ECONOMISER ASSEMBLY

DRG NO : EC-01-GA-001

BOM CHECK SUMMARY

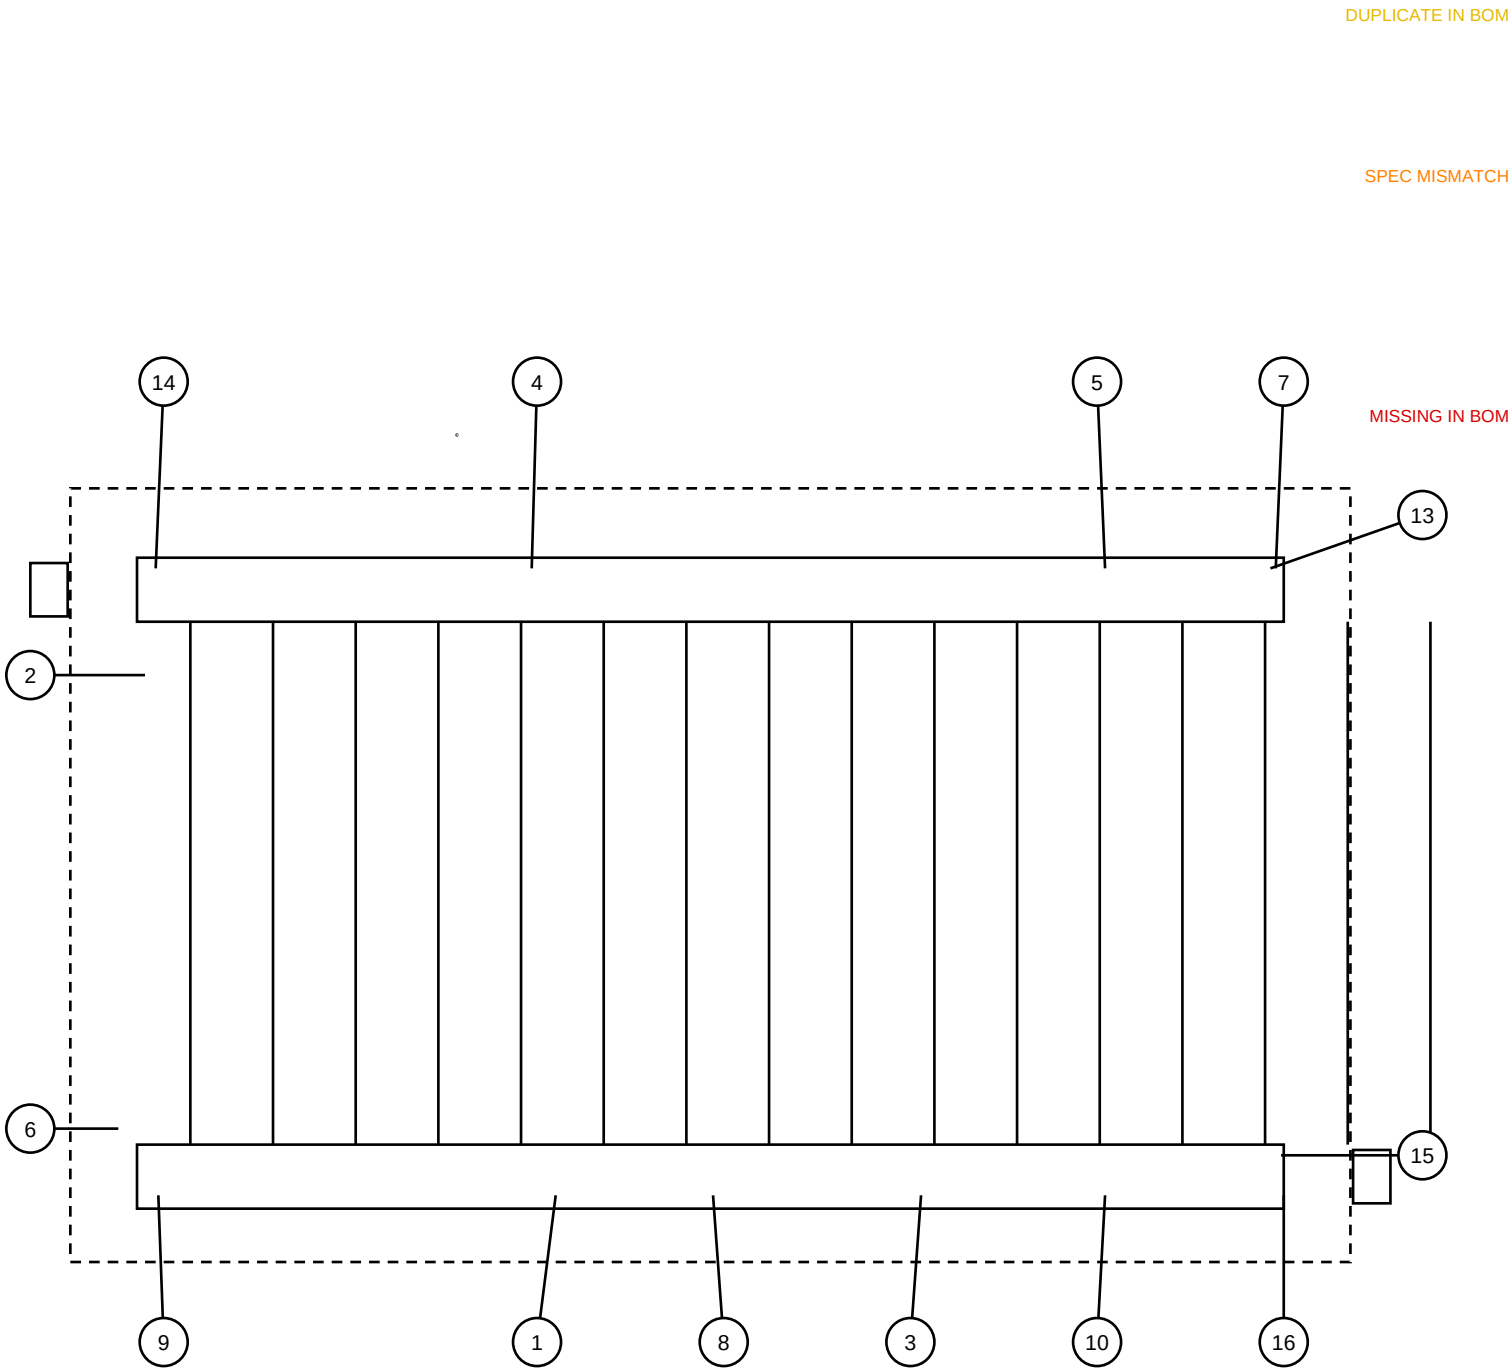
DUPLICATE IN BOM

SPEC MISMATCH

MISSING IN BOM

1. ALL DIMENSIONS ARE IN MM.
2. ALL WELDING AS PER IBR / ASME SEC I.
3. INSULATE WITH 100 THK MINERAL WOOL AND CLAD WITH 0.6 THK ALUMINIUM SHEET. <- BOM LACKS: Cladding

[RED] Item 12 'STUD BOLT M20 X 90 WITH 2 NUTS' (qty 16) is on the drawing but has no BOM line
[ORANGE] Item 6: specification mismatch - dimension: drawing ['200'] vs BOM ['250']
[YELLOW] BOM row 23 'Outlet header 219.1 OD x 8 thk' repeats item 2 (already covered by BOM row 7)
[BLUE] Suggestion (Cladding): the drawing notes imply it, but no matching line was found in the BOM
